MONTGOMERY COUNTY HISTORIC PRESERVATION COMMISSION
STAFF REPORT

Address:	8525 Georgia Avenue, Silver Spring	Meeting Date:	2/11/2026
Resource:	Master Plan Site #37/06 Silver Theatre and Shopping Center	Report Date:	2/4/2026
Applicant:	Pali Eats Silver	Public Notice:	1/2/2026
Review:	HAWP	Tax Credit:	No
Permit No.:	1146698	Staff:	Laura DiPasquale
Proposal:	Installation of rooftop mechanical equipment

The applicants propose to install rooftop mechanical equipment for a new restaurant tenant in the Silver Spring Shopping Center. The new tenant is to be located in the corner unit at the southern entrance drive of the property.

Figure 4: Proposed roof plan showing an existing RTU and proposed kitchen exhaust fan and makeup air units (left) and aerial view of the existing roof (right).

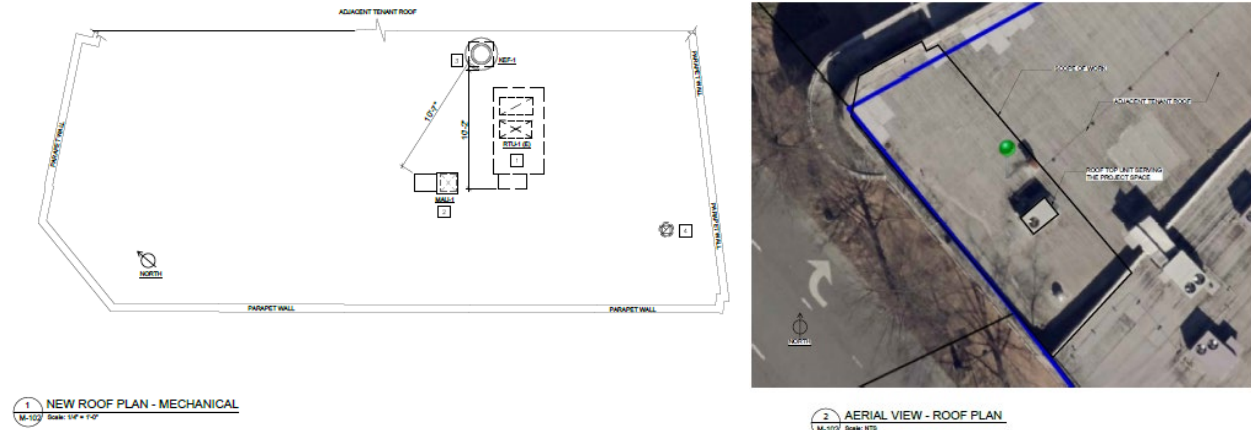
Staff supports the proposed project and recommends approval. Staff finds that the proposed project will not remove or damage any character-defining features of the property, in keeping with *Standards 2 and 9*, and that if removed in the future, will leave the character of the resource unimpaired, per *Standard 10*. Staff finds that, given the one-story height of the subject building and long viewsheds of the property from the neighboring rights-of-way, there may be some visibility of the proposed mechanical equipment, but that presence of perimeter parapets and the setback of the proposed equipment from the building edge will render the equipment inconspicuous from the public right-of-way. Staff finds that this is consistent with the guidance provided by the Secretary of the Interior’s *Guidelines for Preserving, Rehabilitating, Restoring & Reconstructing Historic Buildings*, which extrapolates on the more succinct *Standards*, and specifically recommends “installing mechanical and service equipment on the roof (such as heating and

air-conditioning units, elevator housing, or solar panels) when required for a new use so that they are inconspicuous on the site and from the public right-of-way and do not damage or obscure character-defining historic features.” Staff notes that historic photographs demonstrate that rooftop mechanical equipment has been present and visible on the building since the time of construction, without impairing the character of the resource, and finds that the proposed equipment is similar in height and scale to the historic equipment and other existing rooftop equipment in other units of the resource, and that the new equipment will not substantially alter the exterior features of the historic resource and is compatible in character with the resource, per Chapter 24A-8(b)(1) and (2).

Staff recommends that the Commission **approve** the HAWP application under the Criteria for Issuance in Chapter 24A-8(b)(1) and (2), having found that the proposal will not substantially alter the exterior features of the historic resource and is compatible in character with the purposes of Chapter 24A;
